UNITED STATES PATENT AND TRADEMARK OFFICE

APPLICATION NO.	FILING DATE	FIRST NAMED INVENTOR	ATTORNEY DOCKET NO.	CONFIRMATION NO.
09/989,845	11/21/2001	James E. Lerch JR.	011215	1251

Office Action Summary

DETAILED ACTION

FIG. 3

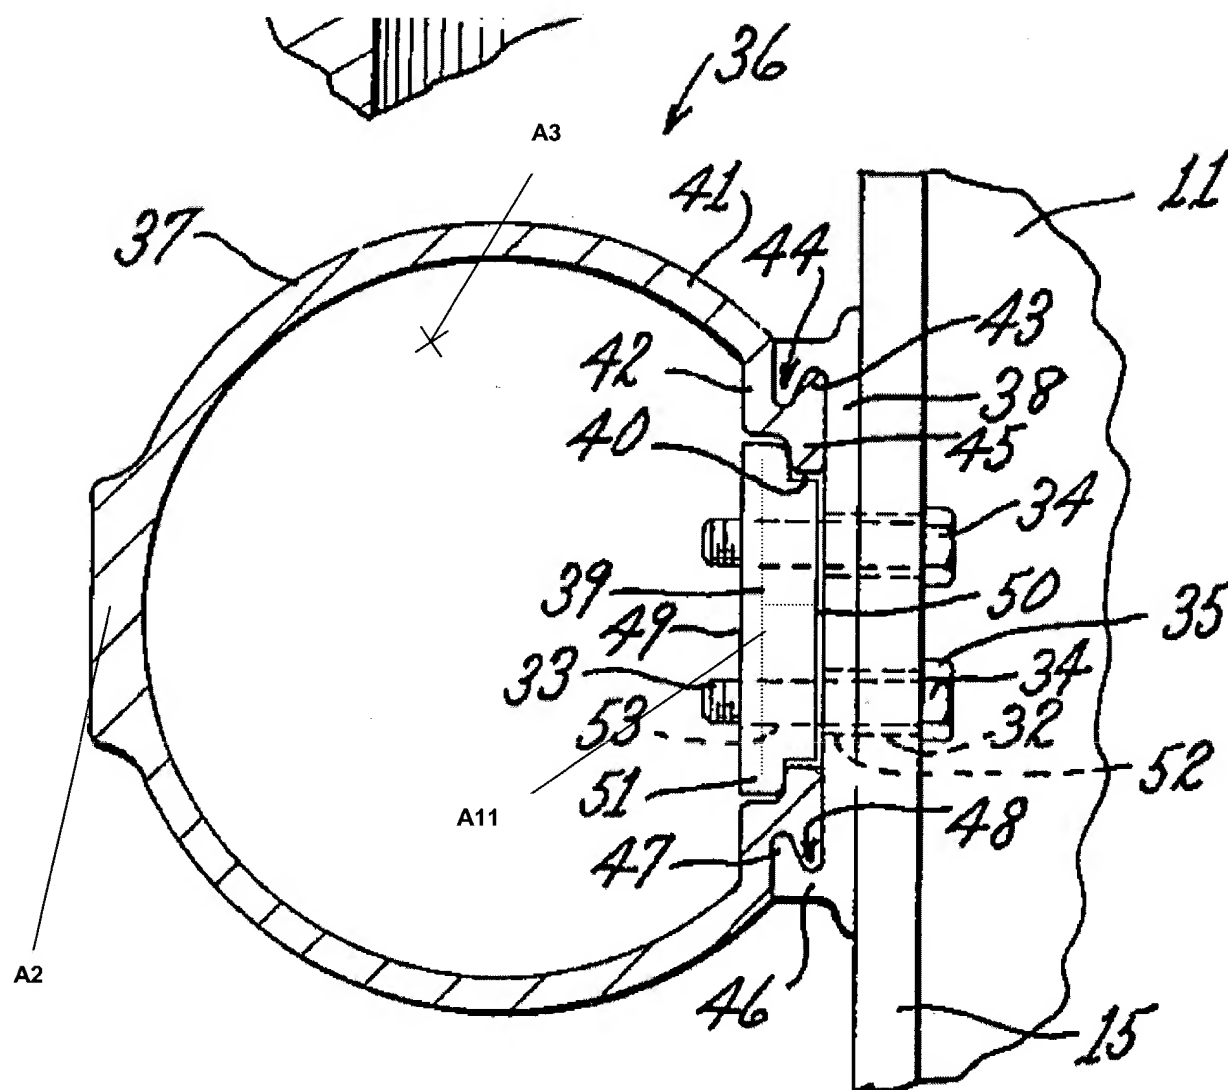
Claims 1-3, 8-10 and 18-20 are rejected under 35 U.S.C. 102(b) as being anticipated by Case, 3,388,892 (see reproduced marked-up attachment).

Regarding claim 1, Case discloses an improvement, in a barrier, comprising at least one longitudinally extending railing **82**, vertically extending posts **56**, and fastening means **42c**.

The railing **82** has at least one generally T-shaped channel **86**. The channel **86** extends in a longitudinal direction **A3** of the railing **82** and at least one leg **A12** of the channel **86** extends inwardly within the channel **86**.

The posts **56** each have an elongated body **A5** and at least two flange segments **58**. The flange segments **58** extend outwardly in opposite directions **A7** and have at least one perforation **71** in each of the flange segments **58**.

The fastening means **42c** are slidably embraced within the channel **86** and the fastening means **42c** extend through the perforation **71** in the flange segments **58** and fastened to the posts **56** to provide a variably select elevation of the longitudinally extending railing.

Regarding claims 2, 9 and 19, the T-shaped channel **86** has an inwardly extending tab **A12** at an end of a leg **A13** of the channel **86**.

Regarding claim 18, Case discloses in Figures 1-3 an apparatus comprising a barrier **32**. The barrier **32** has at least one longitudinally extending railing **82**, vertically extending posts **56**, and fastening means **42c**.

Regarding claims 3, 10 and 20, the railing **82** has another T-shaped channel **90** thereby the railing **82** has at least two T-shaped channels **86,90**.
